Further to your email, please see below. As the internal date to be worked to is noted on the website as today, we will agree a revision to 4th December, but it would seem that the revisions to the drawings are minimal. Please see below my text in blue responding to your queries/ comments.

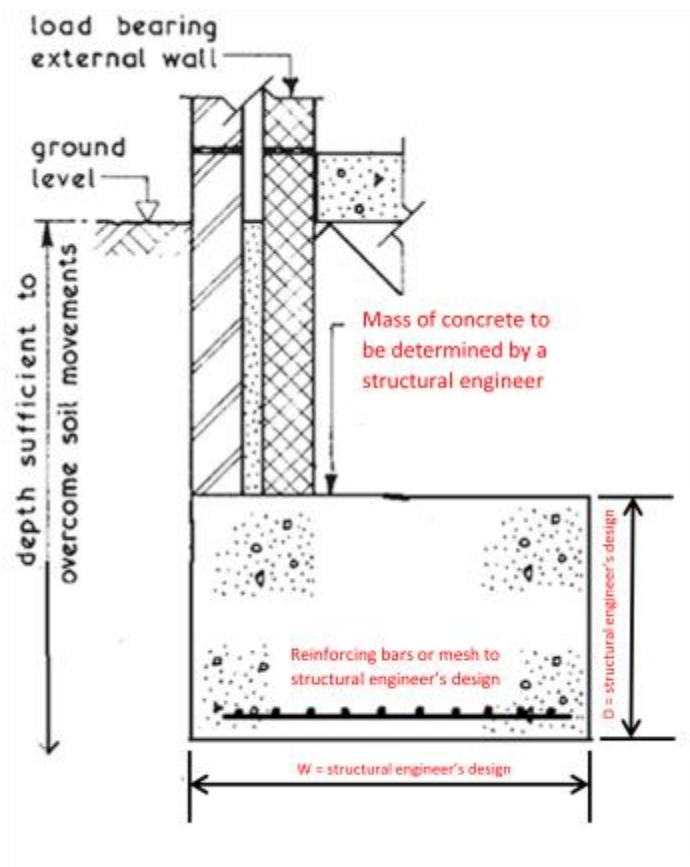
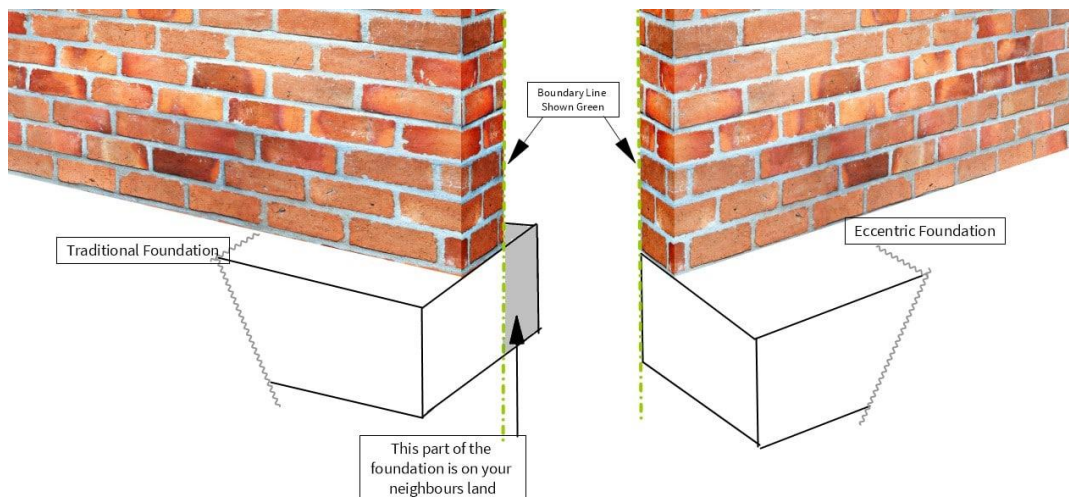
1. I understand that the existing box gutter (on the neighbours at March House) is installed over the boundary between the two properties and is currently overhanging the applicant's property. However, the proposed plans show a development that would be beyond the boundary line. In other words, the proposed box gutter which would be taken the overflow from the neighbours would be 'overhanging' the boundary line.

We can pull the line of the new extension back to allow a small gap to be retained between the two builds. In relation to the foundations themselves, as noted in the previous email the foundations will be eccentrically designed as shown in the images below from Google searches:

By working to these principles the existing gutter can remain overhanging the curtilage of 'Wings' without the new extension encroaching into the neighbouring curtilage.
